ADDENDUM NO. 4

DATE: November 8, 2016
FROM: City of Grand Junction Purchasing Division
TO: All Offerors
RE: 2016 Sewer Interceptor Repair and Replacements IFB-4297-16-DH

2016 SEWER INTERCEPTOR
 REPAIR & REPLACEMENTS
 BID ALTERNATE

NEW MANHOLE MH-1A

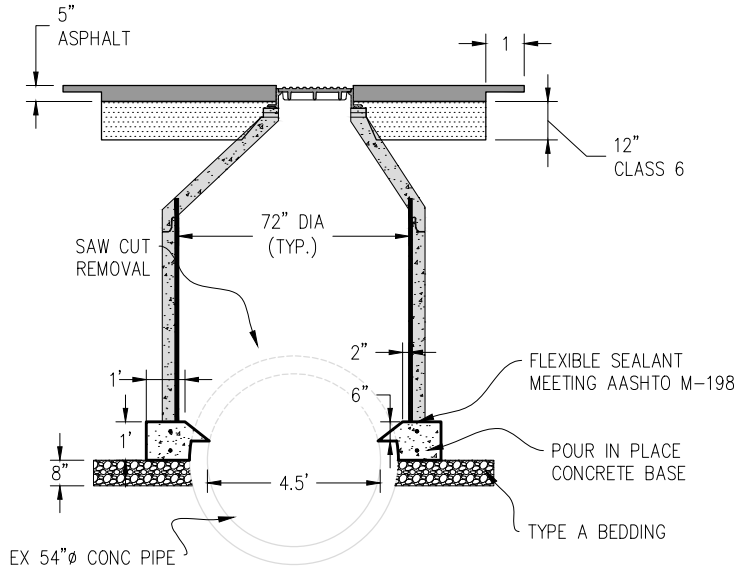
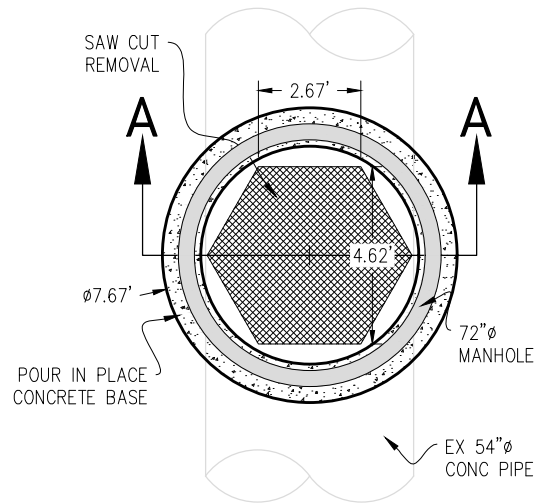
2. See attached bid alternate MH-1A and MH-2A.
3. See attached Pre-Bid Meeting Agenda.
4. Q. We request the bid date be extended two additional weeks. Coordination with subcontractors to obtain the best solution for viable bypassing, excavation and traffic control necessary for this project to obtain the best pricing will require addition time.

6. Video Logs – Available following Prebid Meeting.
7. The City has received and approved request to utilize the existing manholes for cipp installation. This work will require the removal and replacement of the existing cone and barrel section, clean and prep of the box structure and installation of new manhole to include coating/lining. Most likely this work will still require the construction of a few new manholes at various locations per means and methods. The benefits to this method are as follows:

The City will issue an Alternate Bid Schedule to reflect actual quantities for said work above.
